Project	IEEE 802.16 Broadband Wireless Access Working Group < http://ieee802.org/16 >	
Title	Process and rules for development of SNMP solution sets	
Date Submitted	2006-07-18	
Source(s)	Krzysztof Dudzinski Airspan Communications Ltd Joey Chou Intel	[mailto:kdudzins@airspan.com] [mailto:joey.chou@intel.com]
Re:	Call for comments IEEE802.16i-06/001r2	
Abstract	<p>This contribution was written based on the material presenter, discussed and approved by SNMP solution ad-hoc group. Parts of the contribution proposing specific editorial changes to the document are based on material approved by ad-hoc group.</p> <p>Current process of developing 802.16i document doesn't cover the subject of maintenance of 802.16f. The strategy and process are inefficient in all aspects related to SNMP solution sets. This contribution proposes new process and rules to address those issues.</p>	
Purpose	Adopt the contribution and apply required changes in the text of 802.16i document.

Process and rules for development of SNMP solution sets

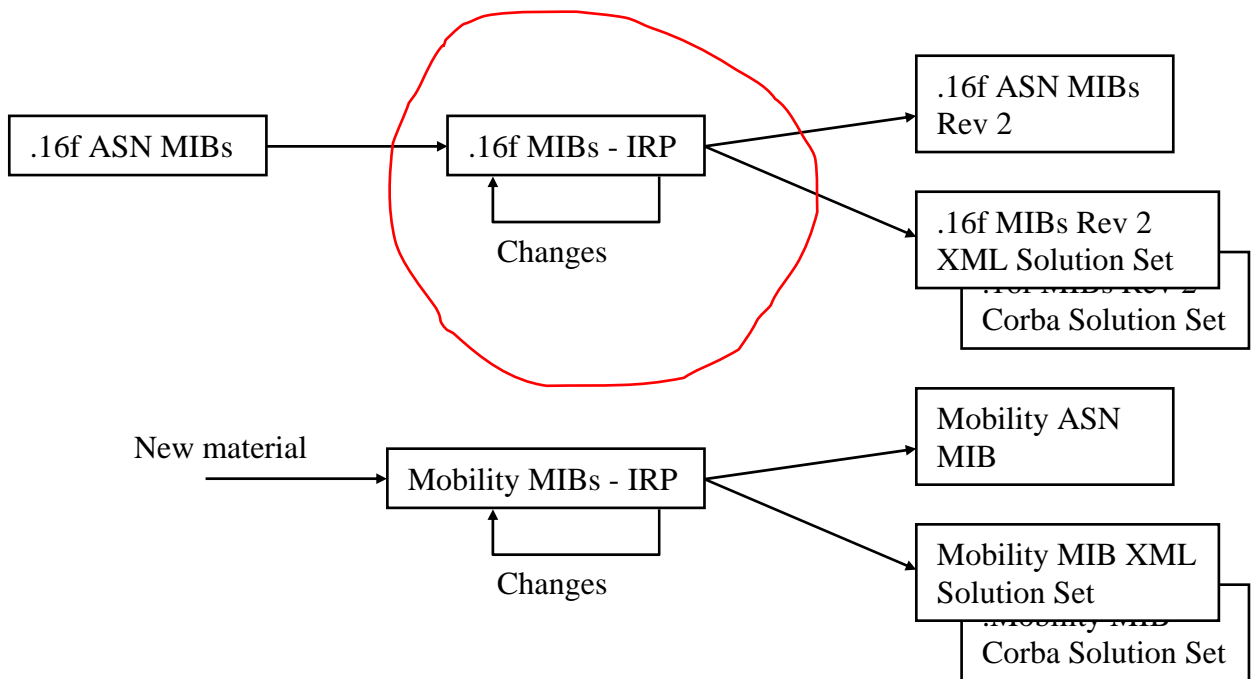
1) How many MIB modules do we plan to have defined in the standard?

1a) 2 MIB modules - current approach (wman2-if-mib and wman2-dev-mib) both redefining all objects defined in .16f MIBs

1b) 3 or more MIB modules – new approach assuming reuse of 802.16f MIBs and creating new MIB module for mobile extensions only

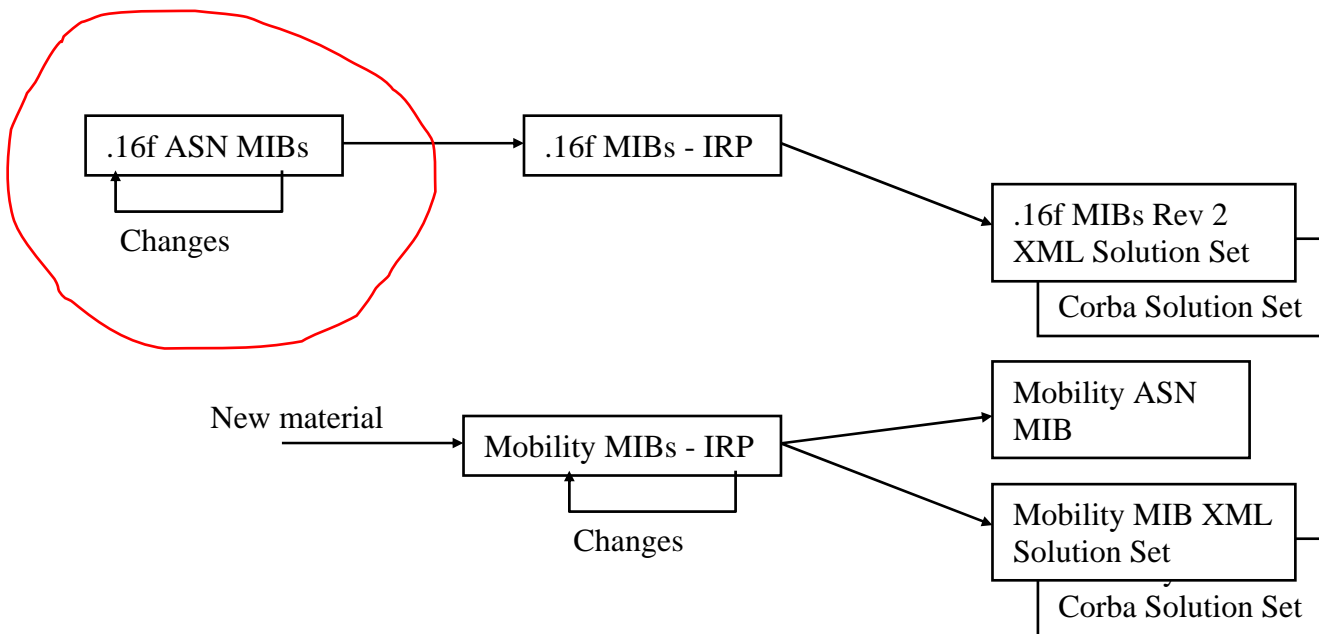
2) What model to apply maintenance changes to?

2a) Apply maintenance changes to IRP model after reverse engineering?

2b) Apply maintenance changes to ASN MIBs before reverse engineering IRP model
